STATE OF IDAHO
DEPARTMENT OF WATER RESOURCES
BENEFICIAL USE FIELD REPORT

Permit No: 29-7437
Original Exam Date: 6/30/1989

1. Current Owner: J R SIMPLOT CO
C/O TERRY UHLING
999 MAIN ST STE 1300
BOISE ID 83707
(208)336-2110

RECORD OF INSPECTION OF DAM

SKETCH OF DAM SHOWING LOCATION OF SPILLWAY AND OUTLET WORKS AND ANY MAINTENANCE PROBLEMS:

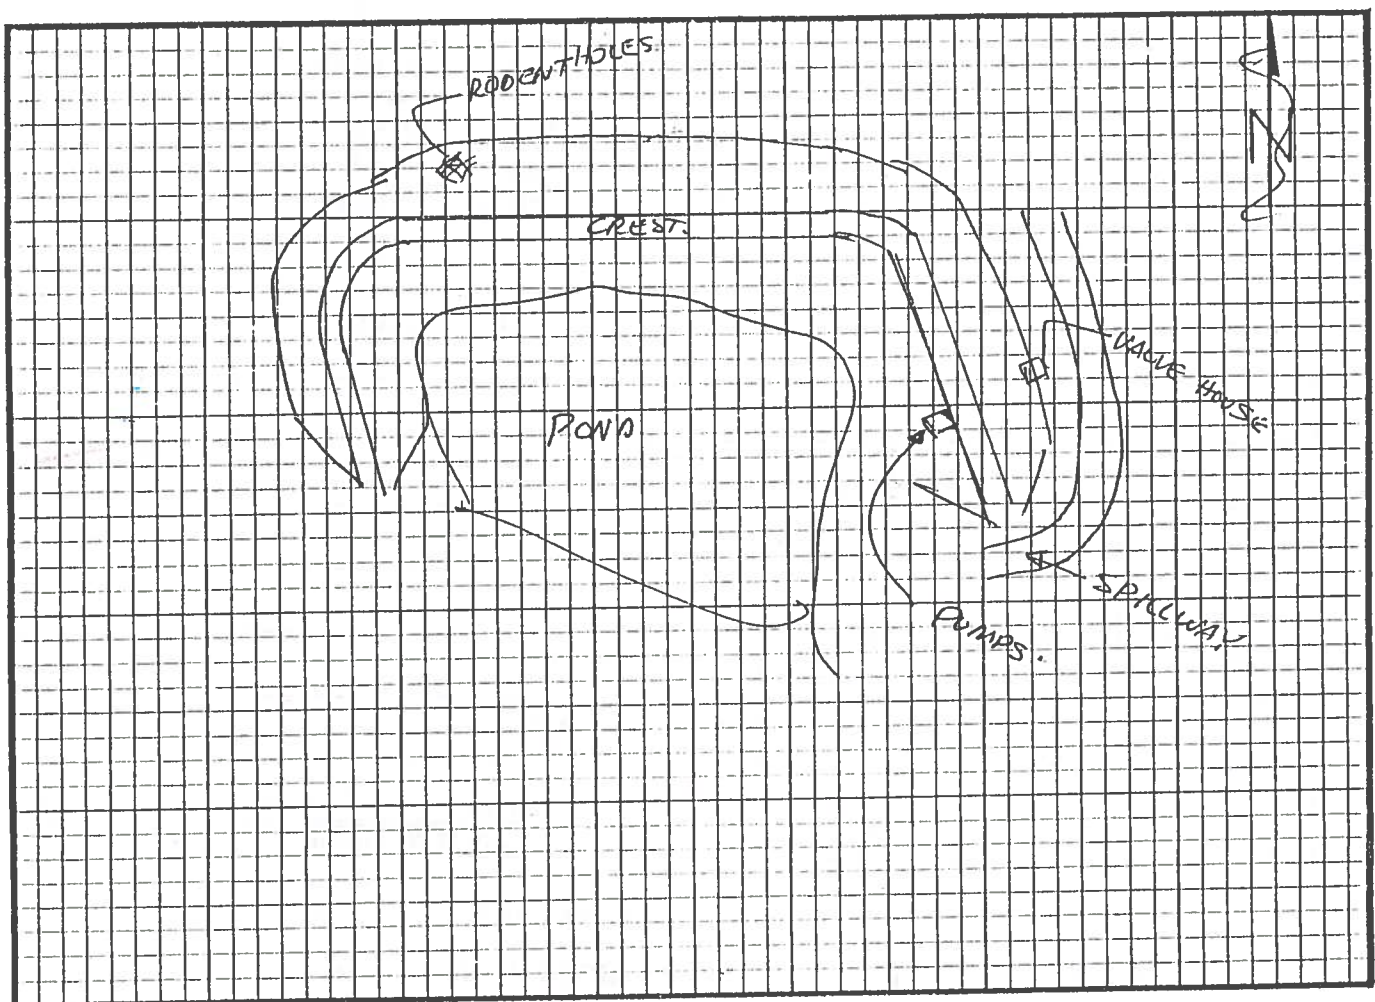
GENERAL CONDITION AND DESCRIPTION OF DAM: EXCELLENT.

- DENNIK FACER INDICATED THE COMPANY WOULD ADISON THE
RODENTS ON THE DAM.

RECOMMENDATIONS: Issue Certificate For 2 Yrs.

- RODENT CONTROL
